ACCESS REPORT

**1, 1A-5 AVON ROAD &
4 BEECHWORTH ROAD
PYMBLE**

**MULTI-UNIT RESIDENTIAL
DEVELOPMENT**

29TH November 2012

Landscape Site Plan

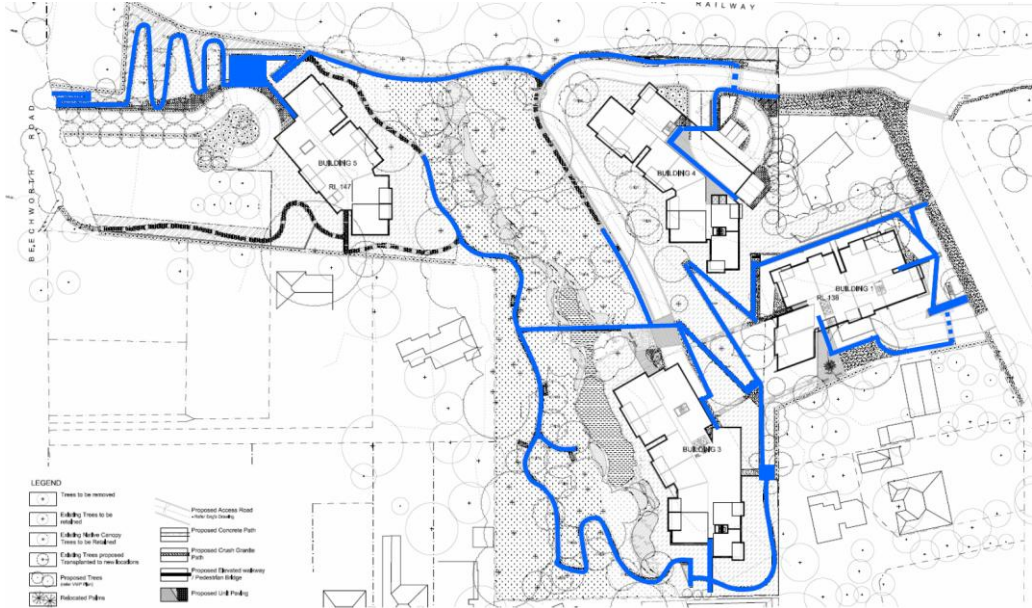
BCA Review	Complies
<p>Site Access Paths -</p> <p>1. The development proposes four buildings 1, 3, and 4 adjoining Avon Road and building no 5 adjoining Beechworth Road.</p> <p>Building No. 1</p> <p>2. The development proposes a site entry to Building 1 adjacent to the driveway that commences at approximately RL137.00. The 2400mm width entry path travels to a crossing over the driveway and then continues as a 1200mm width walkway not exceeding 1:20 to the principal building entry @RL138.00 in accordance with ASI428.1 to satisfy Table D3.1 and Part D3.2 of the BCA.</p> <p>3. The entry forecourt provides ample circulation space to approach and entry the building lobby.</p> 	<p>YES</p> <p>YES</p>

BCA Review	Complies
<p>Building No. 3</p> <p>4. To access Building No 3 the development proposes a site entry on the northern side of Building 1 that commences at approximately RLI 40.00 with a 1:14 ramp travelling into the site and along the northern side of Building 1 to a turn @RLI 36.80 which incorporates a resting point with a seat.</p> 	YES
<p>5. The 1200mm width accessible ramp continues through a landscaped area with a series of ramps and rest landings to the principal building entry @RLI 28.00 in accordance with ASI 428.1 to satisfy Table D3.1 and Part D3.2 of the BCA.</p>	YES
<p>6. The entry forecourt provides appropriate circulation space in accordance with ASI 428.1 to enter the building lobby @RLI 28.00 to satisfy Table D3.1 and Part D3.2 of the BCA..</p>	YES
<p>7. In addition to the ramp systems there are stairway links for people who are ambulant who wish to use the stairways.</p>	YES

BCA Review	Complies
<p>Building No. 4</p> <p>8. To access Building No 4 the development proposes a site entry on the boundary that commences at approximately RL148.00 with a 1:14 ramp travelling into the site and adjacent to the driveway for approximately 20 metres to a driveway crossing @RL 146.80. The 1:14 ramp continues for a further 20 metres to the No. 4 building entrance is at RL148.00, which incorporates a large under-croft area and vehicle drop-off point.</p> <p>9. The entry forecourt provides appropriate circulation space in accordance with ASI428.1 to enter the building lobby @RL148.00 to satisfy Table D3.1 and Part D3.2 of the BCA.</p>  <p>10. The plans show an additional 1:14 ramped pathway adjoining the northern side of the driveway that continues into the site to a junction @RL142.50, which forms an accessible through site link to Building No. 5 and Beechworth Road.</p> <p>11. The elevated bridge link across the valley shall provide moderate gradients of less than 1:25.</p> <p>12. This accessible through site link shall be detailed in accordance with ASI428.1 to enable equitable access for people with mobility impairments to satisfy Table D3.1 and Part D3.2 of the BCA.</p> 	<p>YES</p> <p>YES</p> <p>YES</p> <p>YES</p>

<p>Building No. 5</p> <p>13. To access Building No 5 the development proposes a site entry at Beechworth Road that commences at approximately RL159.00 with a 1:14 ramp travelling into the site and adjacent to the driveway for approximately 40 metres to RL156.50 where the plans show a large landscaped area with a meandering ramp system</p>	<p>YES</p>

BCA Review	Complies
<p>that continues for a further 100 metres to the No 5 building forecourt and entrance @RL148.00, which incorporates an under-croft area and vehicle drop-off point.</p>  <p>14. This accessible pathway to Building No 5 shall be detailed in accordance with AS1428.1 to enable equitable access for people with mobility impairments to satisfy Table D3.1 and Part D3.2 of the BCA.</p>	YES
<p>Lobby Entrances</p> <p>15. With respect to the accessibility of entrance lobbies future development applications for each building will provide details of accessible doorways and circulation spaces in accordance with AS1428.1 to satisfy Part D3.2 and Table D3.1 of the BCA.</p>	YES
<p>Internal Building Access</p> <p>16. The plans indicate that each building shall provide lifts that will be detailed to travel to all levels to ensure equitable to satisfy Part D3.2 and Table D3.1 of the BCA.</p>	YES

<p>External Stairways</p> <p>17. In accordance with part D3.3(a)(ii) of the BCA the external stairways that form a primary access path to a building entrance will be detailed at construction stage with handrails on both sides to the requirements of AS1428.1, step nosings, closed risers and tactile ground surface indicators.</p>	YES
<p>Valley Walk</p> <p>18. The plan below illustrates the wide range of wheelchair accessible pathways that meander through the site which confirm a high degree of accessibility and inclusive access.</p>	YES

Ground Floor entry level – RL138.0

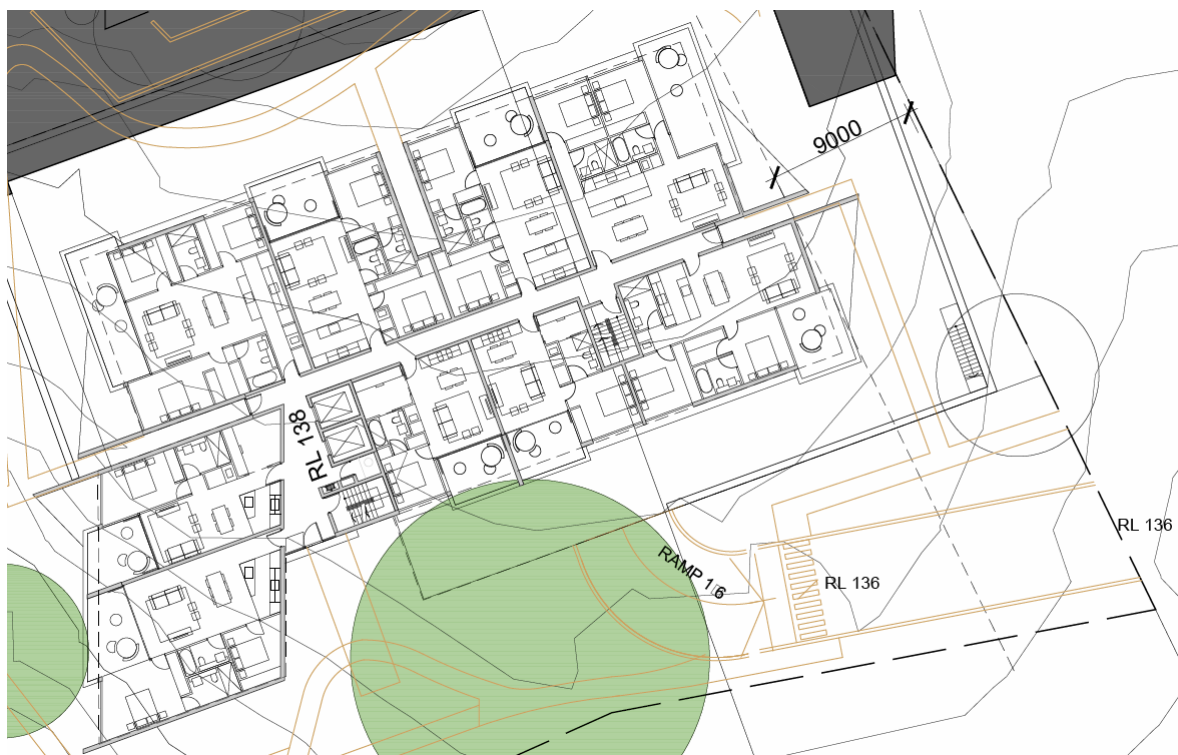
BCA Table D3.1 & Part D3.2	Lobby Entrances <p>The principal entrance lobby on the southern side of the building @RL138.0 can provide a level threshold entry with 920mm minimum doors (more if pivot hinge) providing 850mm minimum clear opening and circulation spaces to comply with ASI428.1 to satisfy Part D3.2 of the BCA.</p>	YES at CC stage
BCA Part D3.3 & Table D3.1	Lobby & Common Corridor Access <p>The entrance lobby incorporates lifts that facilitate easy access to the basement car park levels and upper floor levels to access the designated adaptable apartments.</p> <p>With regard to lift landings the plans show an irregular shaped area approximating 8000mm X 2000mm average width that facilitates appropriate Turning and Passing Areas and ample doorway circulation spaces to comply with ASI428.1 and satisfy Table D3.1, Parts D3.2 and D3.3 of the BCA.</p> <p>With regard to the common corridors and unit entrances the plans show 1200mm width corridor with an indented area adjoining a fire isolated stairway that facilitates a 1800mm X 2000mm Passing</p>	YES YES YES

Clause	Accessibility Assessment – Common Domain	Compliance
	Area to comply with AS1428.1 and satisfy Table D3.1, Parts D3.2 and D3.3 of the BCA.	
	To fully satisfy Part D3.3 of the BCA the end of the central corridor shall be modified to provide a 1540mm X 2070mm Turning Area, which can be readily achieved at the construction certificate stage.	YES
	The 1200mm width central corridor will also require an adjustment to 1250mm to satisfy Council's DCP 55 in terms of "visitable housing" requirements.	YES
	The lift and corridor accessways at each level provide wheelchair accessible paths of travel to all apartment entrance doorways to satisfy Table D3.1 and Part D3.2 of the BCA.	YES
BCA Part E3.6	Lift Access The plans indicate the lift cars will be at least 1400mm X 1600mm as specified by Part E3.6 of the BCA and AS1735.12 – <i>Lifts For People With Disabilities</i> .	YES
BCA D3.3(a)(ii) D3.8	Stairways In accordance with part D3.3(a)(ii) of the BCA the stairway at the external forecourt and other non fire-isolated stairs will be detailed at construction certificate stage with handrails on both sides to the requirements of AS1428.1, step nosings, closed risers and tactile ground surface indicators.	YES

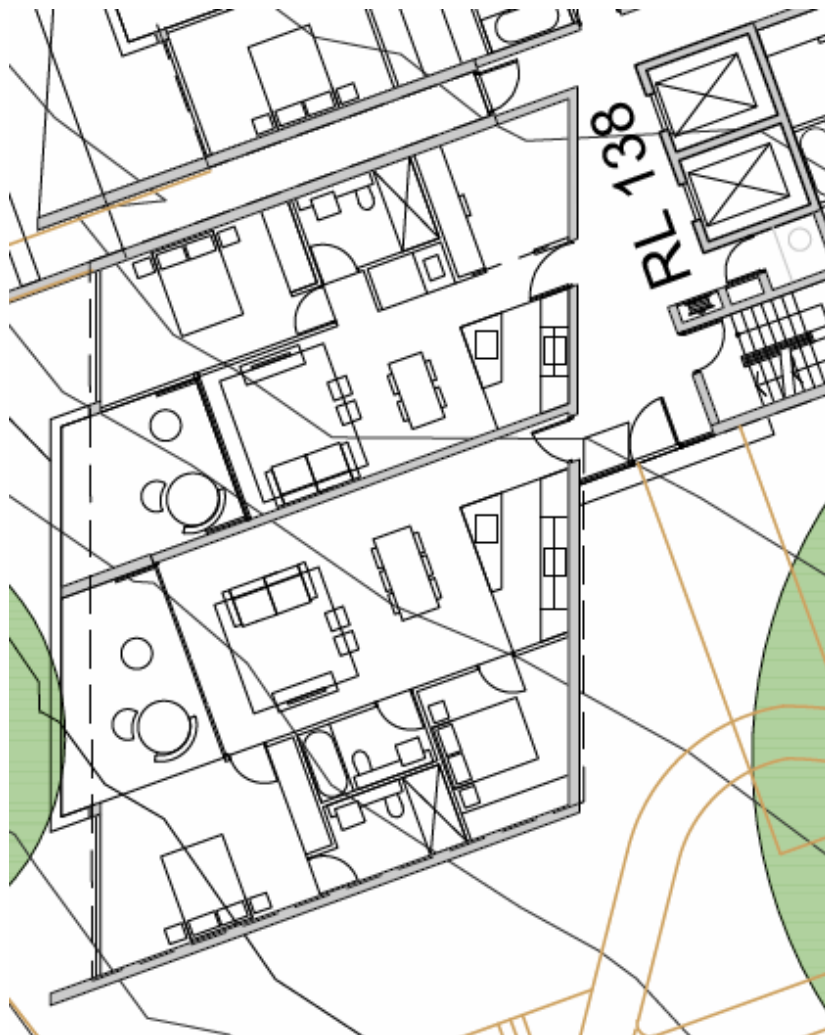
AS4299 Cls 4.3.7	<p>Interior: general – The internal corridors provide 1000mm minimum width to the living areas, kitchens, bathrooms, to enter a <u>main bedroom</u>, additional bedrooms/studies with internal stud walls which are non-load bearing that can be modified to facilitate appropriate doorway circulation space to comply with AS1428/4299.</p> <p>Doors and Door Hardware</p> <p>While the plans do not indicate 920mm external door widths, 870mm internal door widths and lever handles these details shall be provided at construction drawing stage to confirm compliance.</p>	<p>YES</p> <p>YES</p>
AS4299 Clause 4.7	<p>Living and Dining rooms – The plans show combined living and dining area on a single level with sufficient area to provide a 2250mm diameter turning area to comply with this clause.</p>	<p>YES</p>
AS4299 Clause 4.5	<p>Kitchen – The kitchens incorporate a free standing island bench that can be adapted to provide 1550mm X 1550mm minimum circulation to comply with AS4299.</p> <p>With regard to the “adaptability” of the kitchen it is evident that the cupboards and layout provide adequate space to accommodate a wall oven, cooktop and 800mm width adjustable bench unit while the kitchen sink will remain in the same position pre and post adaptation.</p> <p>Therefore, subject to confirmation of the installation of kitchen cupboards, appliances and the like at the construction documentation stage it is apparent that the kitchen will comply with AS4299.</p>	<p>YES at CC stage</p> <p>YES</p>

Clause	Adaptability Assessment	Compliance
AS4299 Clause 4.6	Main bedroom – The plans show the main bedroom for these Units can provide the required circulation spaces around a queen sized bed to achieve 4300mm X 3200mm plus a built-in robe; The post adaptation plans would illustrate 1200mm minimum on two sides and 1540mm X 2070mm circulation space adjacent a queen sized bed with enhanced door access and overall internal manoeuvring area to comply with AS1428/4299.	YES at CC stage YES
AS4299 Cls 4.7	Bathroom – The plans show the bathrooms or ensuites that could facilitate a 2000mm X 3000mm with a layout of sanitary facilities which complies with AS1428/4299.	YES at CC stage
AS4299 Cls 4.4.3	Toilet – The size and layout of the bathroom or ensuites would need to be adjusted at CC stage to enable the toilet to provide 1250mm clearance in front of the pan to comply with AS4299.	YES at CC stage
AS4299 Clause 4.8	Laundry – The laundry closets provide adequate space for a washing machine, drier and basin, while the installation of bi-fold doors or similar will facilitate the required minimum 1550mm X 1550mm clear circulation space in front of the appliances to comply with AS4299.	YES

AS4299 Cls 3.5(b)	Outdoor Private Open Space – The plans show outdoor balcony terrace areas adjacent living areas for these units with sliding doors for convenient access to balcony terraces, which provide adequate area to perform a 180 degree wheelchair manoeuvre. With regard to doorway thresholds to balconies and terraces the details of finished floor levels (FFL) shall be confirmed at construction certificate stage to confirm 1:8 maximum gradient threshold ramps at doorways with a 35mm maximum rise to facilitate wheelchair access and thereby comply with AS1428/4299.	YES
